# NEWMAR CORPORATION WARRANTY DEPARTMENT

## TECHNICAL SERVICE BULLETIN

DATE ISSUED	MODEL YEAR(S) AFFECTED	TSB #
04/10/2015	2014-2015	Recall 15V-149 TSB 416

### Notice of wiper blade replacement requirement

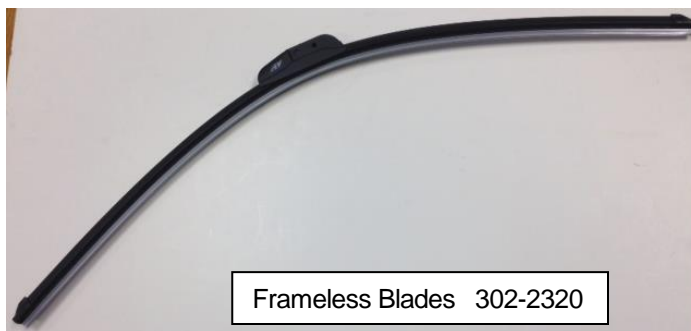
***Frameless style windshield wiper blades P/N 302-2320 supplied on designated coaches may separate from wiper arm connector when wiper system is operated at the high speed setting.***

Frameless wiper blades P/N 302-2320 MUST be immediately replaced with framed wiper blades P/N 302-1320 supplied with this service bulletin.

### To Remove Frameless Blade

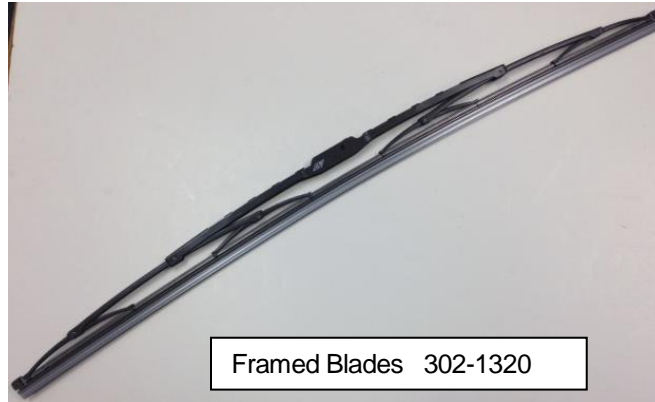
1. Remove frameless blade 302-2320 from wiper arm, driver and passenger side.  
DISPOSE OF REMOVED BLADES

1. Lift plastic cover to expose arm hook.
2. Squeeze plastic clip
3. Push blade back to remove from arm
